RE: Modifications to Niagara Region Wind Farm (Addendum 2)

The addendum report proposes relocation (<10m shift from original proposed location) of turbines 18, 32 and 35. Upon review of the addendum report, MNR is satisfied that the Natural Heritage Assessment requirements of Ontario Regulation 359/09 have been met.

Reference: Niagara Region Wind Farm NHA/EIS Addendum for Relocating Turbines T18, T32 and T35

Figure No.
 6.32

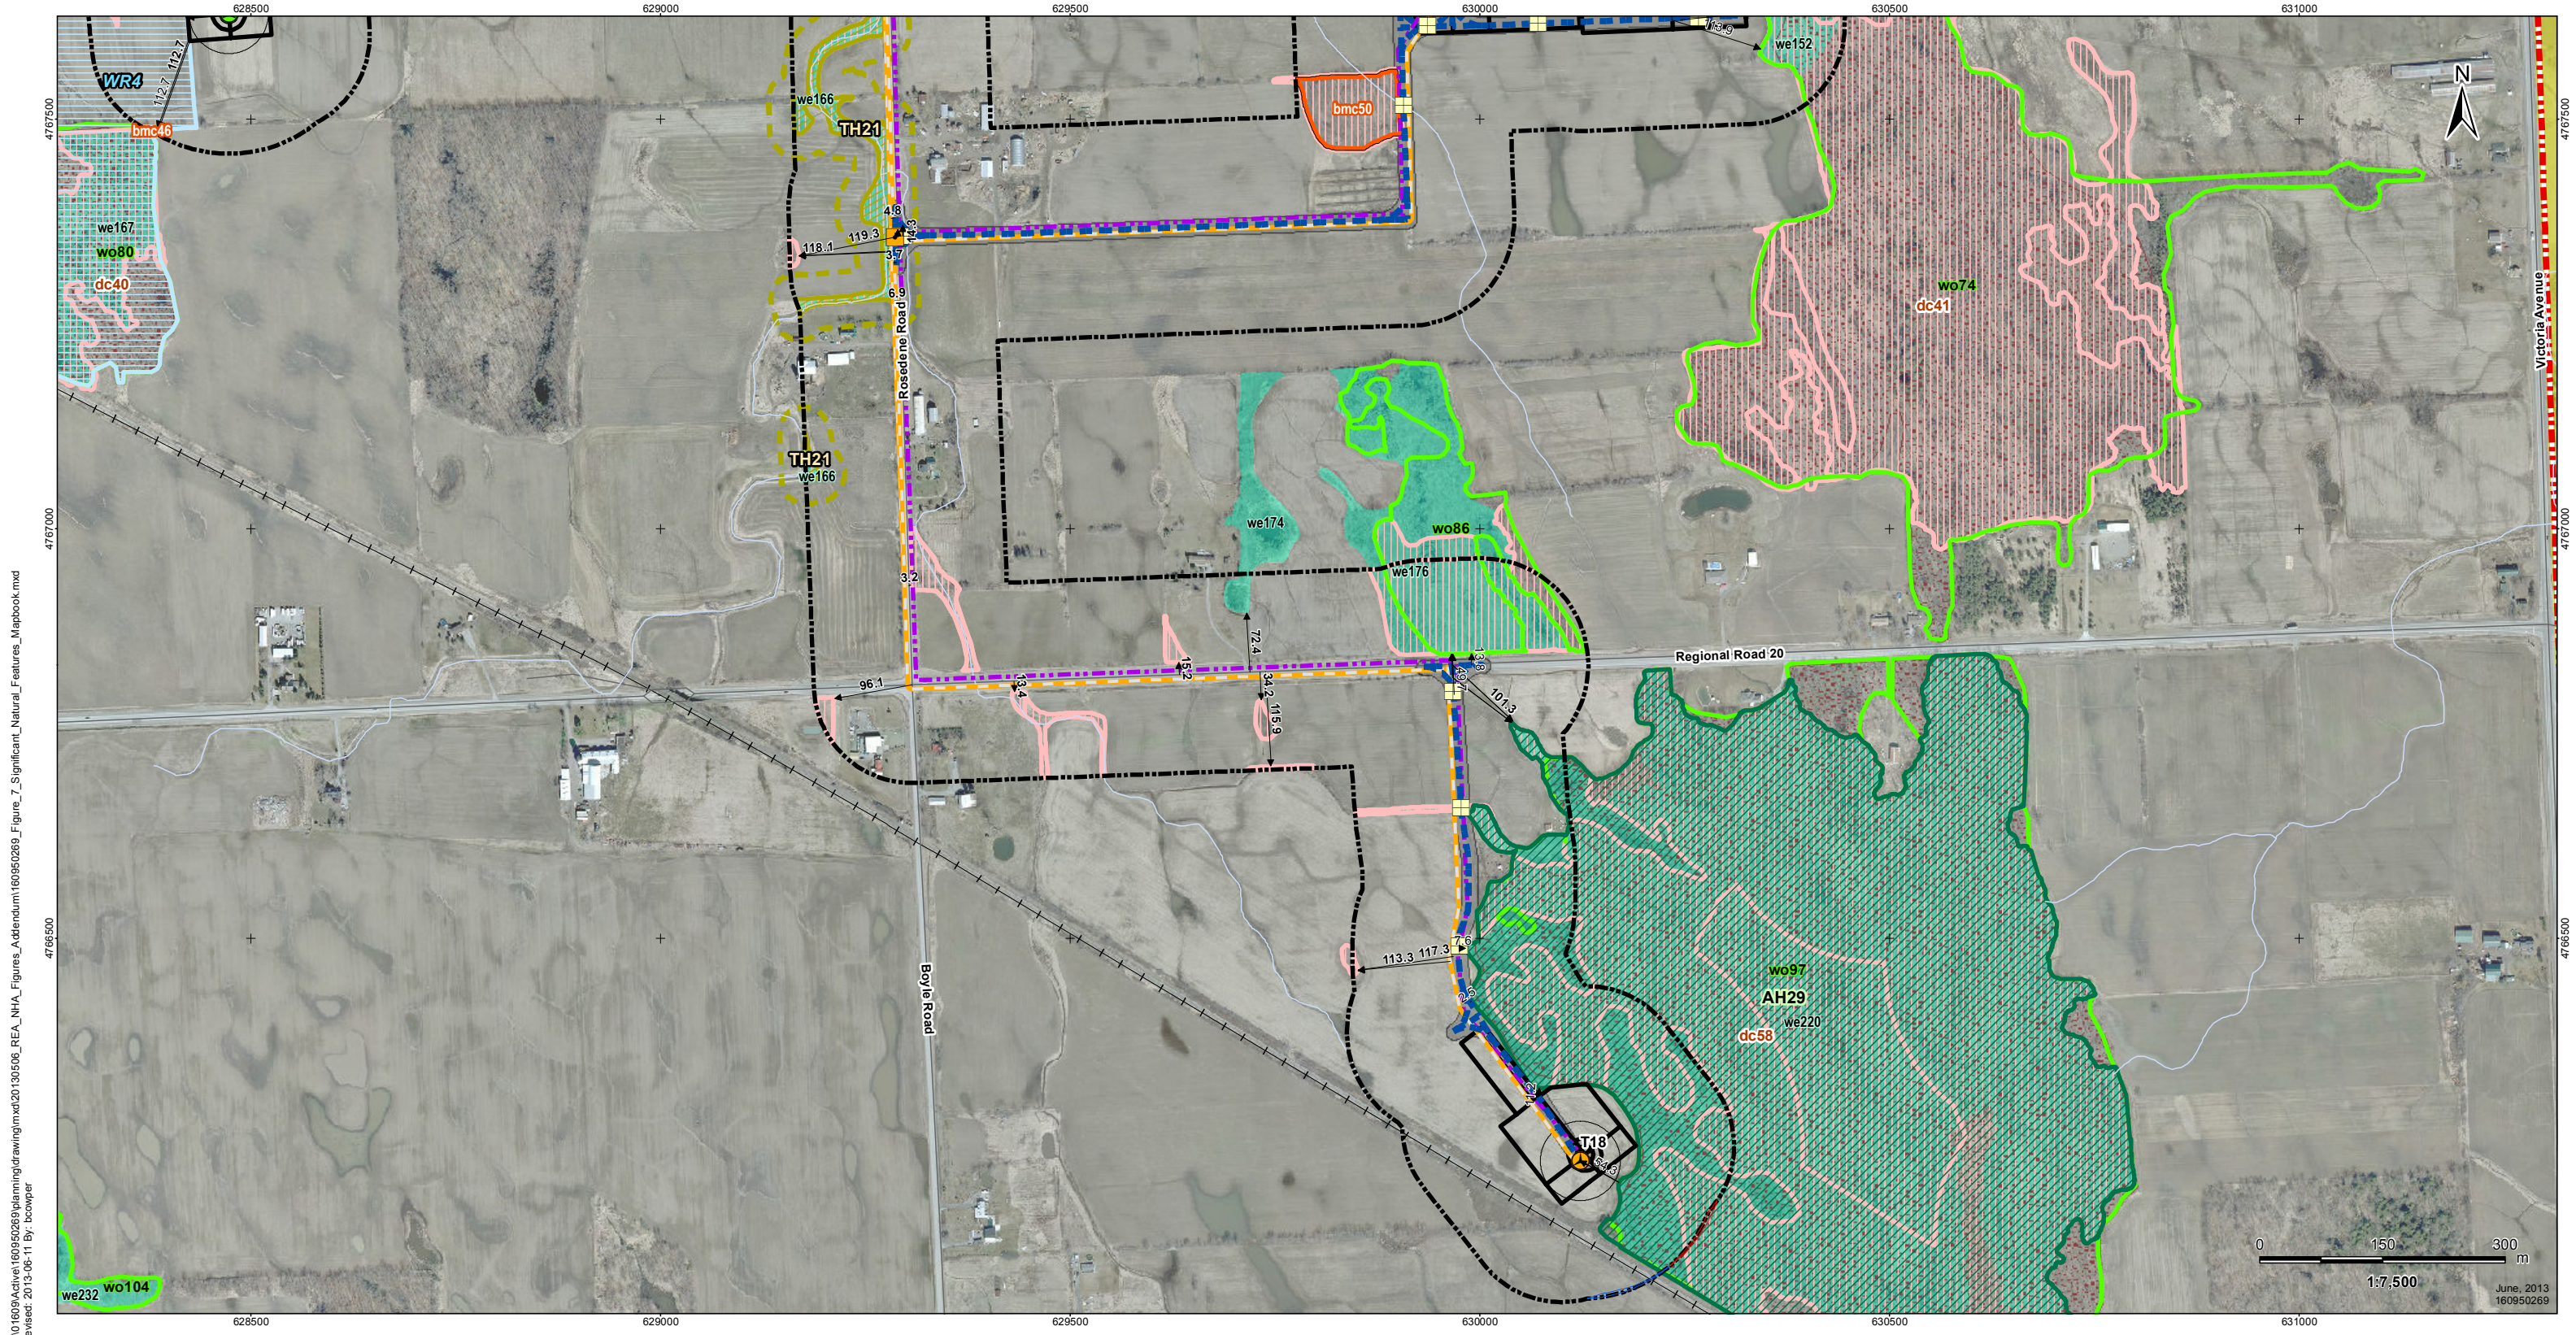
No natural heritage features were identified during site investigations as occurring within the zone of investigation. No significant features or candidate significant wildlife habitat features were identified as occurring within the expanded zone of investigation (Revised **Figure 6.32**).

Figure No.
 7.17

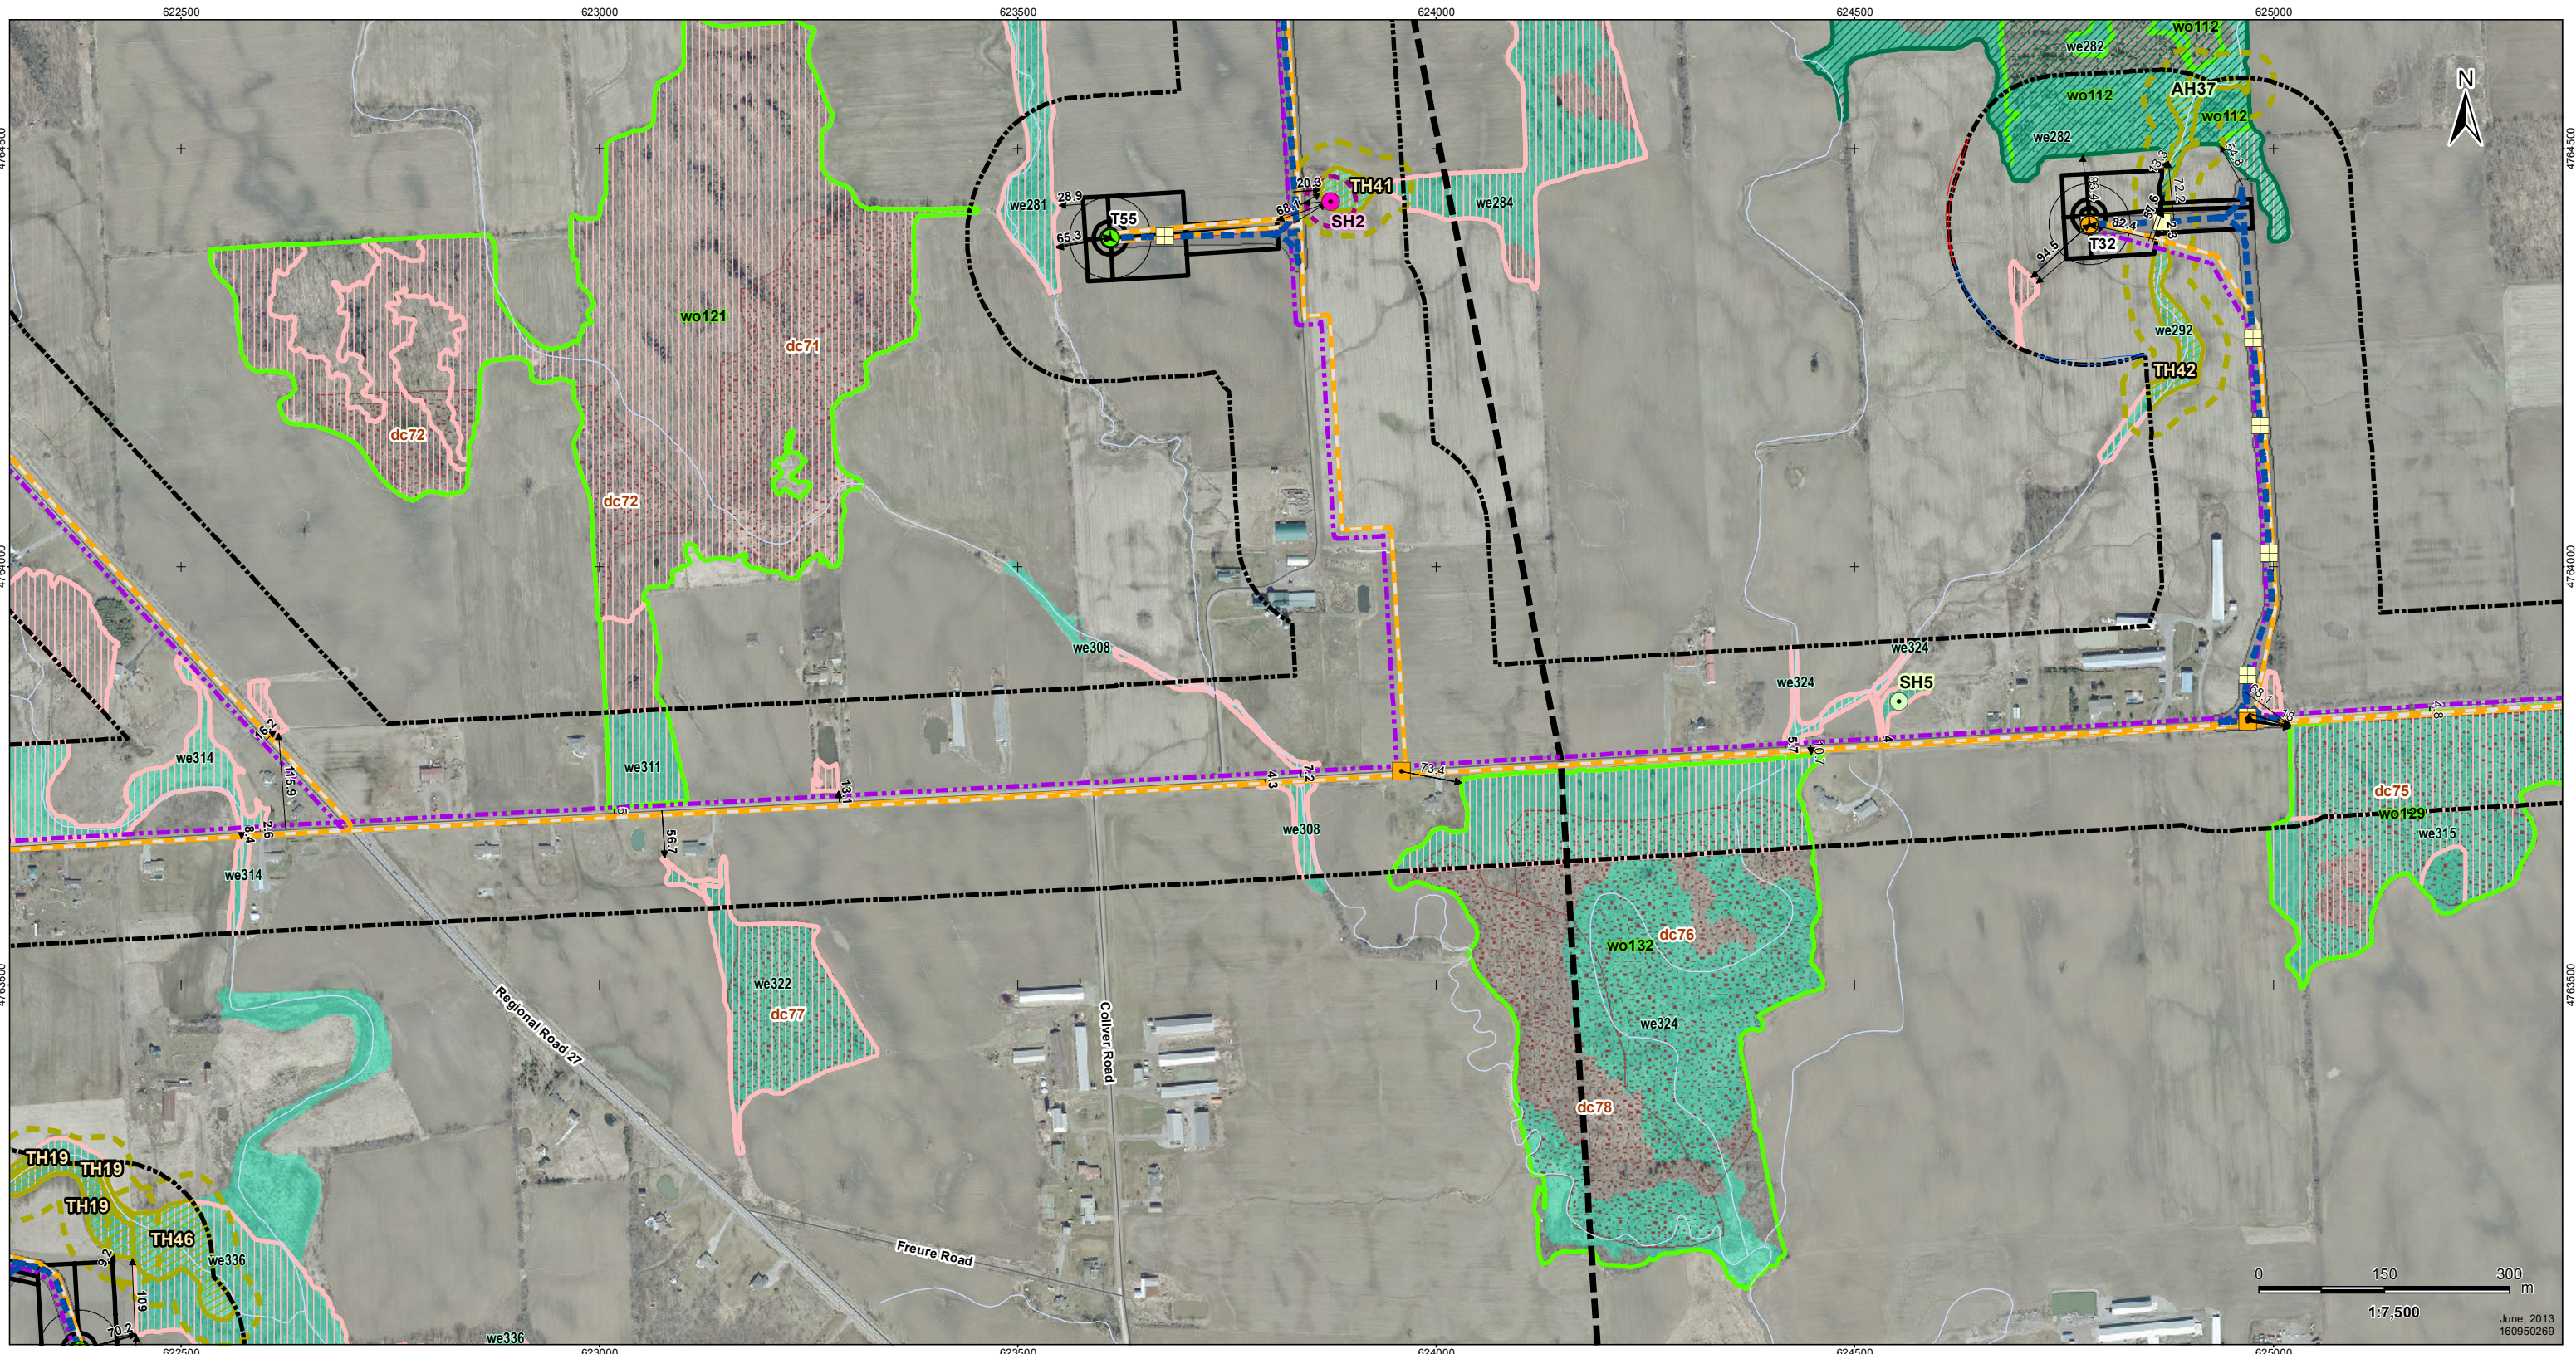
Significant features identified within the revised zone of investigation include significant wetland (we220) and significant woodland (wo97). Significant wildlife habitat features within the zone of investigation include amphibian habitat (ah29). Generalized Significant wildlife habitat includes a deer congregation area (dc58), woodland vole habitat, woodland raptor nesting habitat and woodland area sensitive bird breeding habitat (in wo97) (Revised **Figure 7.17**). These features were identified and assessed as significant in the NHA/EIS. No new significant natural heritage features were identified.

Significant natural features found in or within 120 m of the revised turbine locations are shown on **Figures 7.17, 7.29 and 7.32**. Based on the evaluation of significance, the following natural features have been identified as significant natural features in or within 120 m of revised locations of Turbines 18 and 32 for which an EIS addendum is required:

Figure No.
 7.29

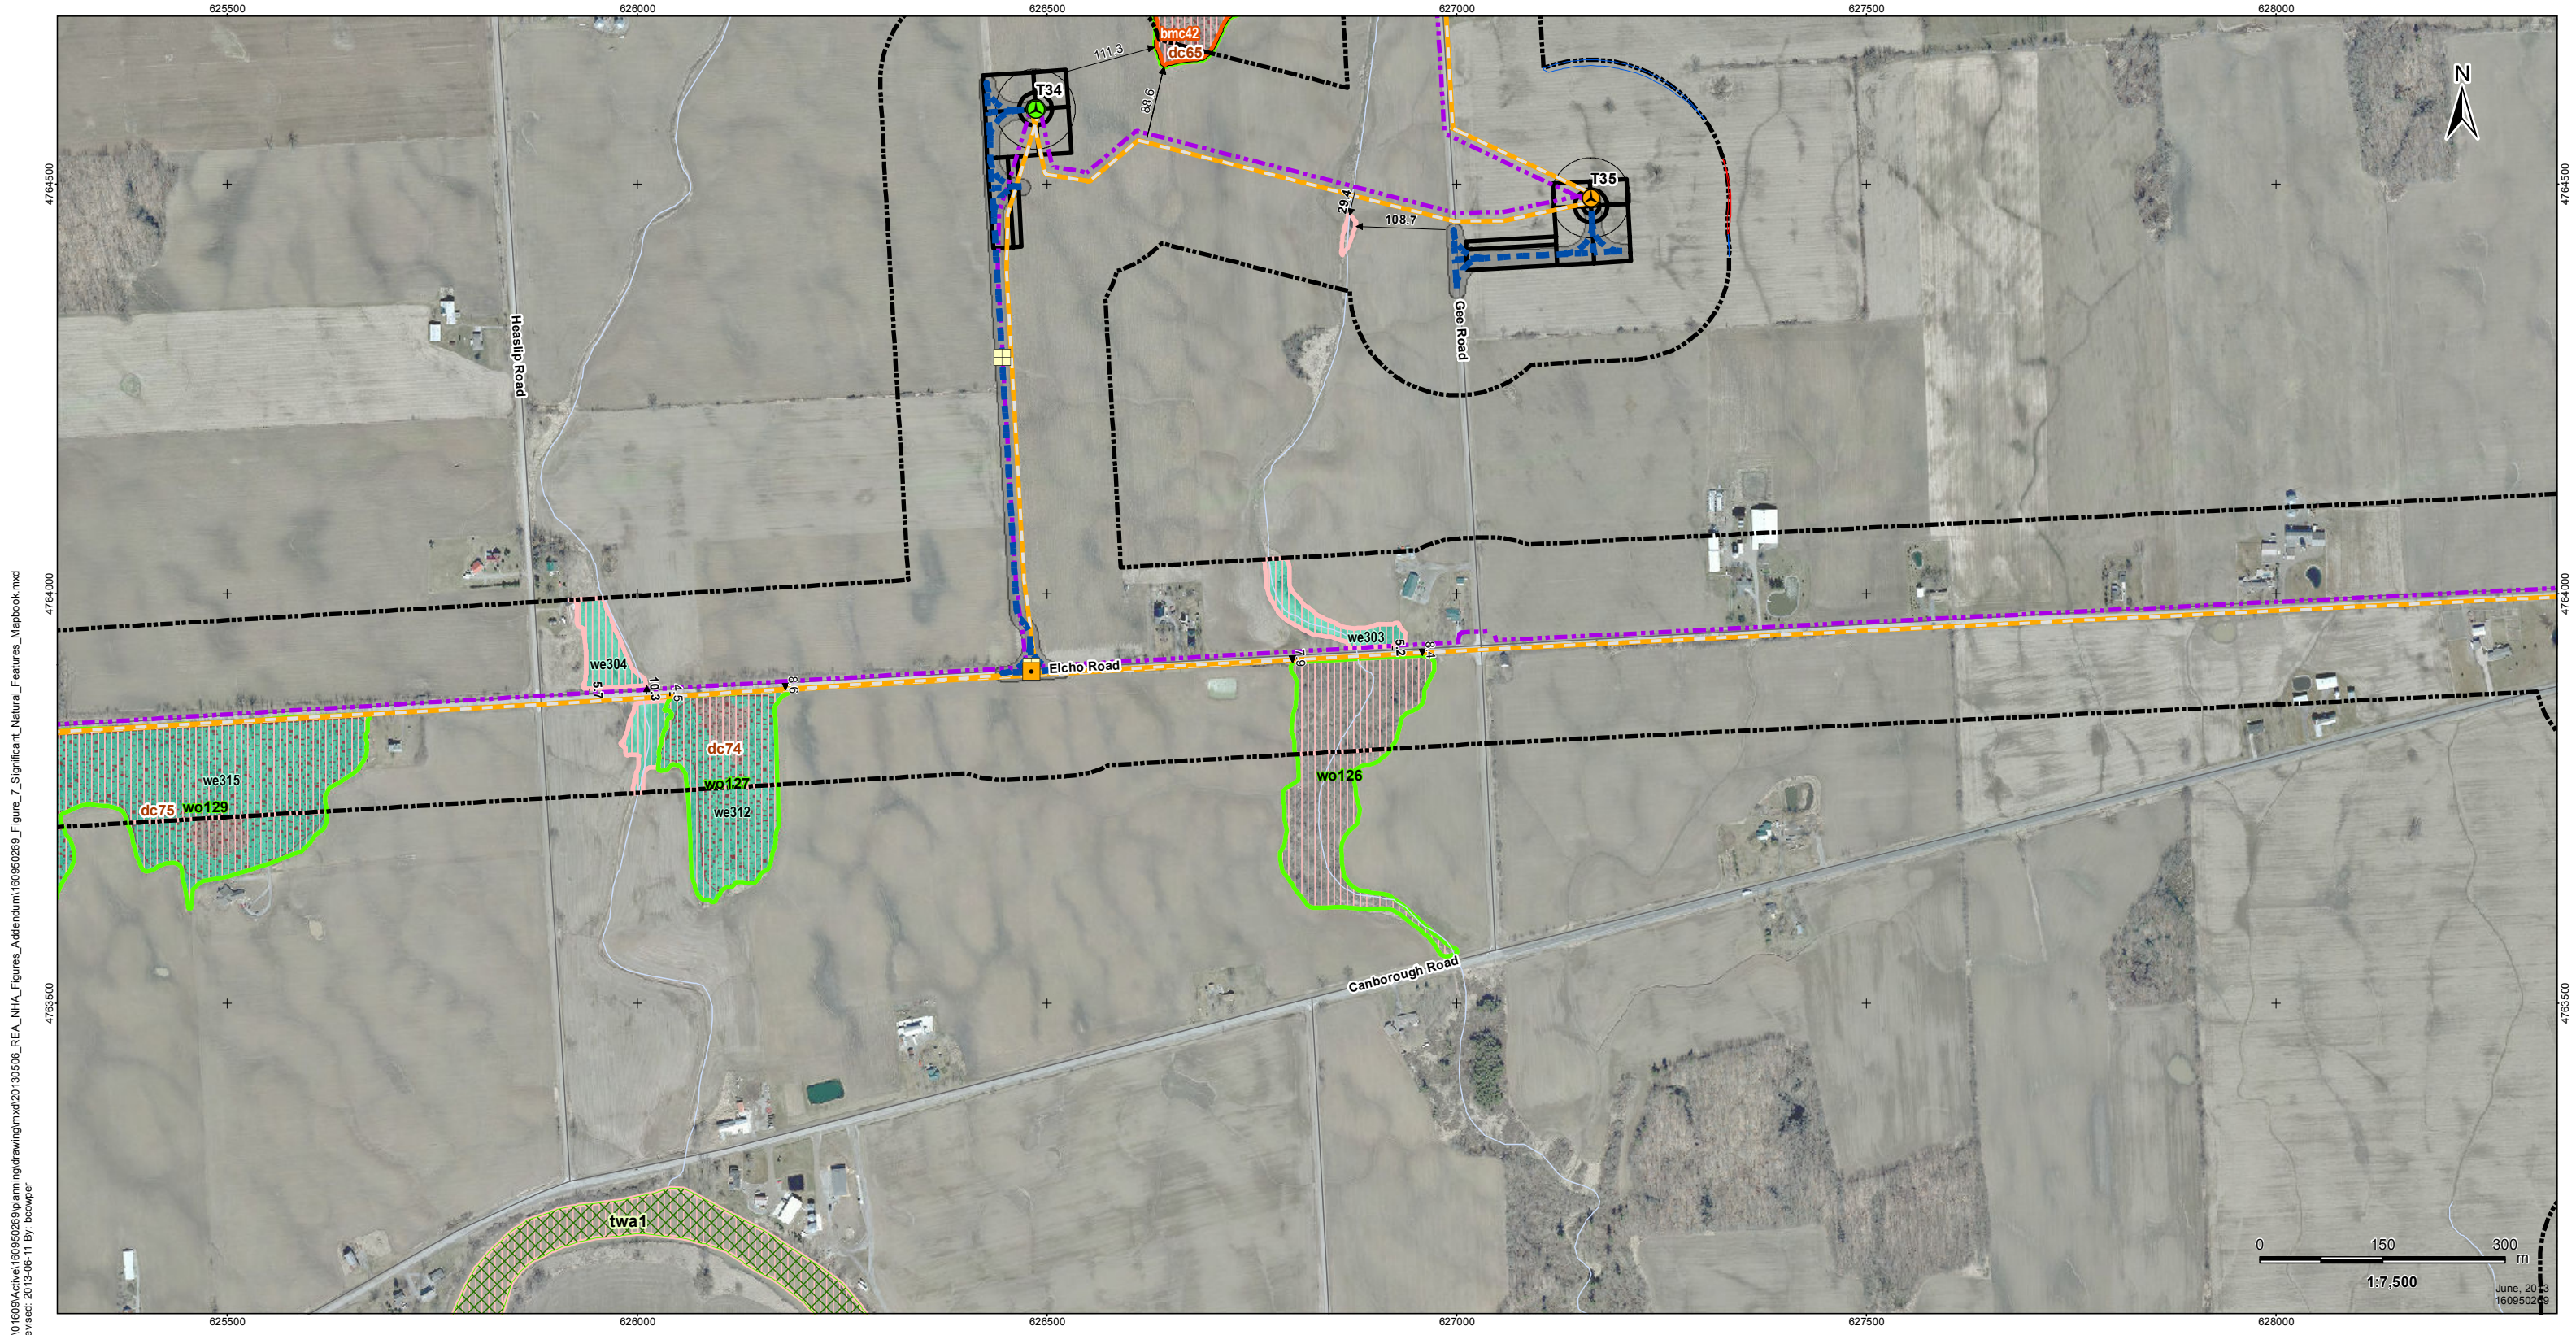
Significant features identified within the revised zone of investigation include significant wetlands (we282 and we292) and significant woodland (wo112). Significant wildlife habitat features within the zone of investigation include amphibian habitat (ah37) and turtle nesting habitat (th42). Generalized significant wildlife habitat includes terrestrial crayfish habitat (Revised **Figure 7.29**). These features were identified and assessed as significant in the NHA/EIS. No new significant natural heritage features were identified.
